**PROJECT:** City of Sanborn, Iowa  
Wastewater Treatment Facility Improvements

#### **ADDENDUM NO. 4**

This ADDENDUM NO. 4 hereby revises the Contract Documents dated August 16, 2018. Revisions made herein shall become a binding part of the Contract Documents.

Sheet  
P705\_ADD#4

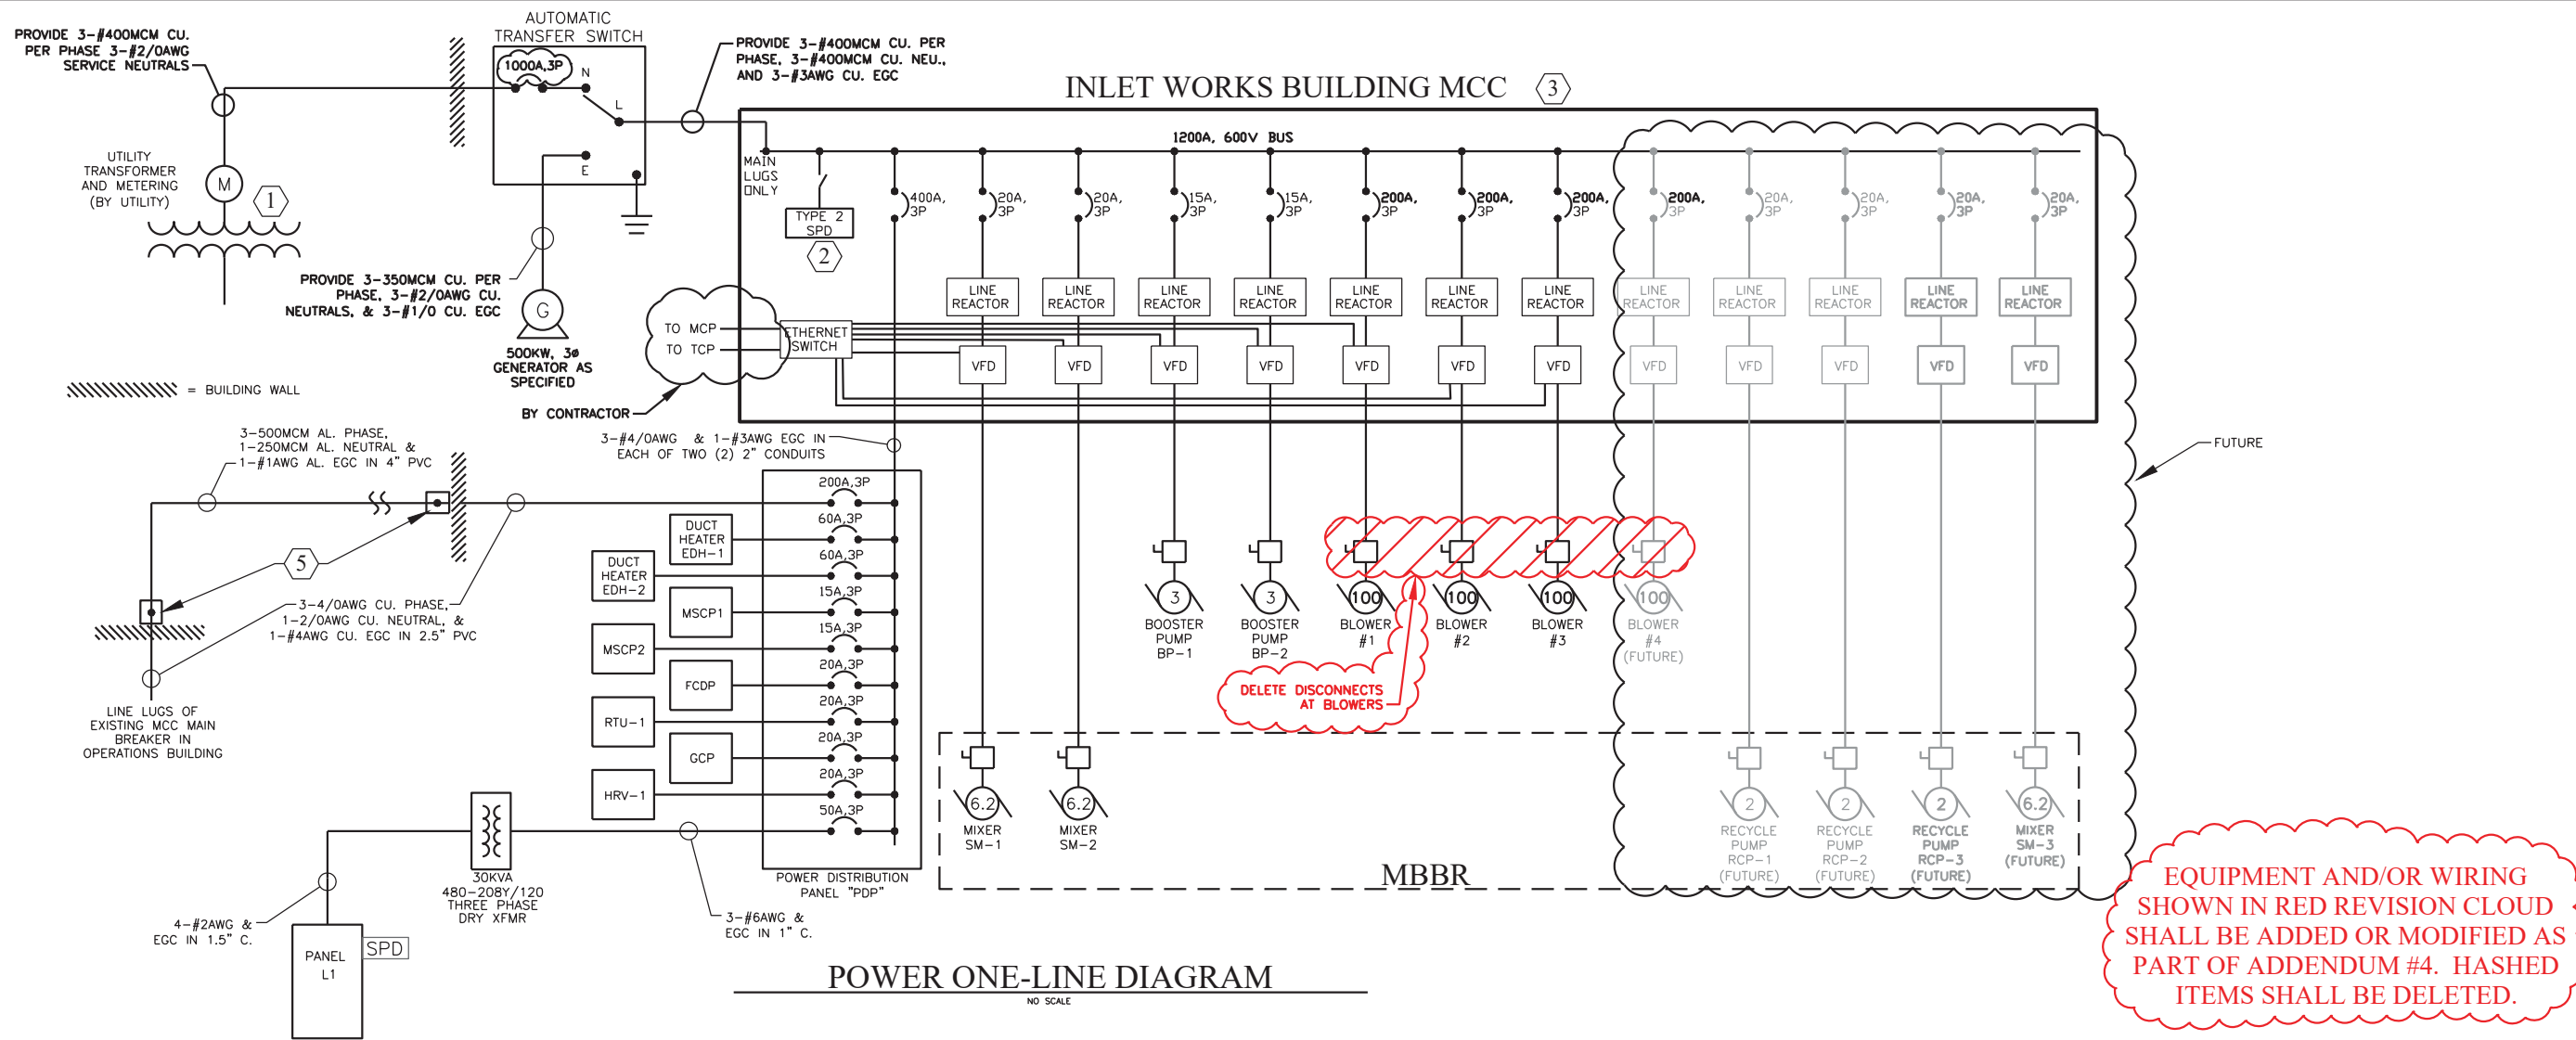
Replace Sheet P705\_ADD#1 with revised Sheet P705\_ADD#4. The Drawing has been revised as follows:

- Booster Pump BP-1 and BP-2 schedule modification.

Replace Sheet E14\_ADD#2 with revised Sheet E14\_ADD#4. The Drawing has been revised as follows:

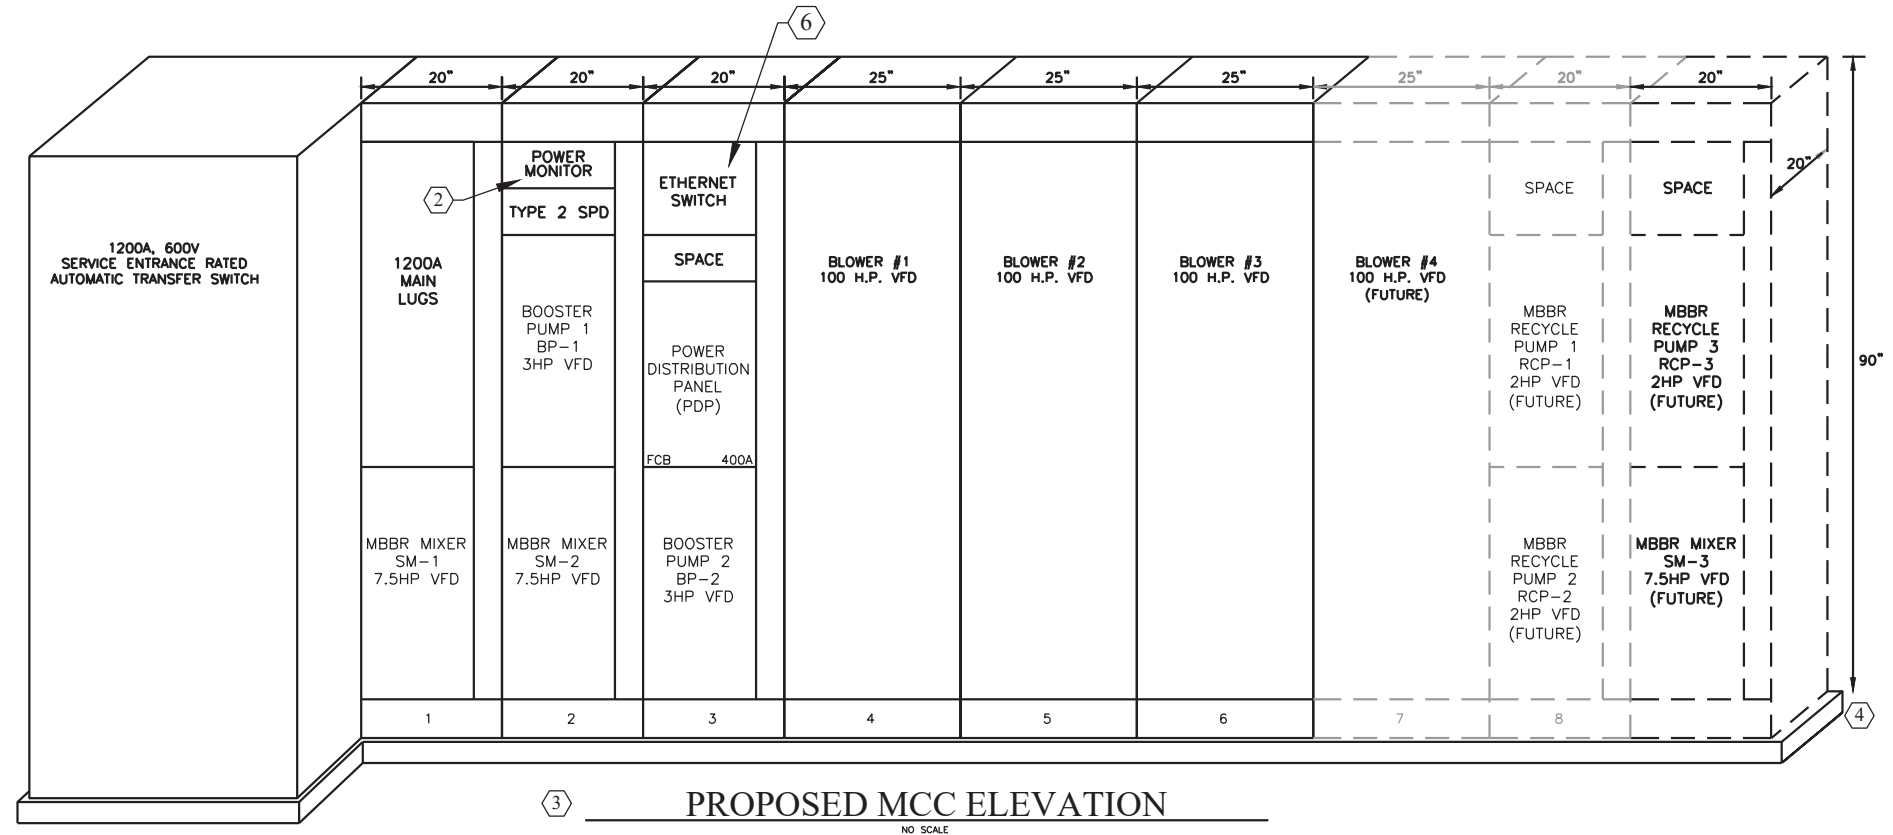
- Blower disconnect modification
